UNITED STATES DEPARTMENT OF THE INTERIOR BUREAU OF LAND MANAGEMENT

Revised Cement Table Multi-bowl Wellhead schematics Wellhead Procedure

Cotton Draw Unit 205H Cement Table

WELL NAME & NO.: Cotton Draw Unit 205H SURFACE HOLE FOOTAGE: 0150' FSL & 1450' FEL

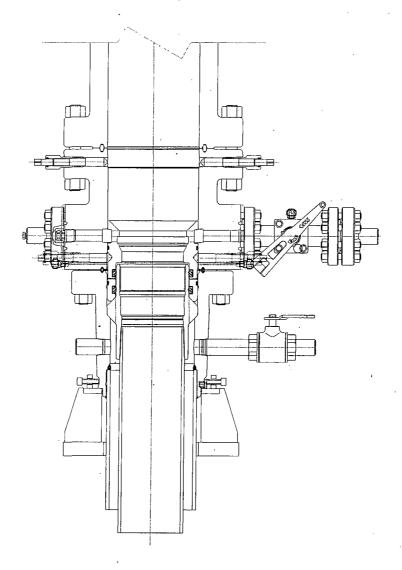
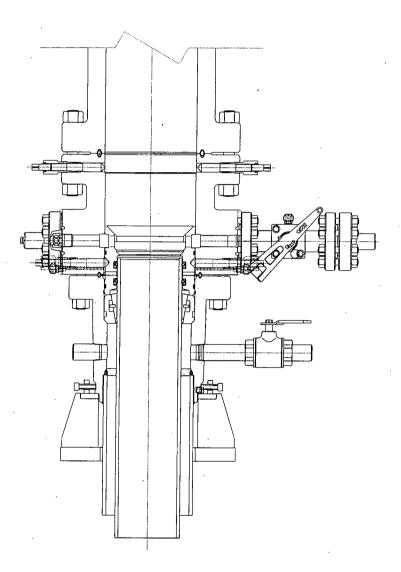
- 3. Operator has proposed a multi-bowl wellhead assembly. This assembly will only be tested when installed on the surface casing. Minimum working pressure of the blowout preventer (BOP) and related equipment (BOPE) required for drilling below the surface casing shoe shall be 5000 (5M) psi.

- a. Wellhead shall be installed by manufacturer's representatives, submit documentation with subsequent sundry.
 - b. If the welding is performed by a third party, the manufacturer's representative shall monitor the temperature to verify that it does not exceed the maximum temperature of the seal.

- c. Manufacturer representative shall install the test plug for the initial BOP test.
 - d. Operator shall perform the intermediate casing integrity test to 70% of the casing burst. This will test the multi-bowl seals.

- e. If the cement does not circulate and one inch operations would have been possible with a standard wellhead, the well head shall be cut off, cementing operations performed and another wellhead installed.
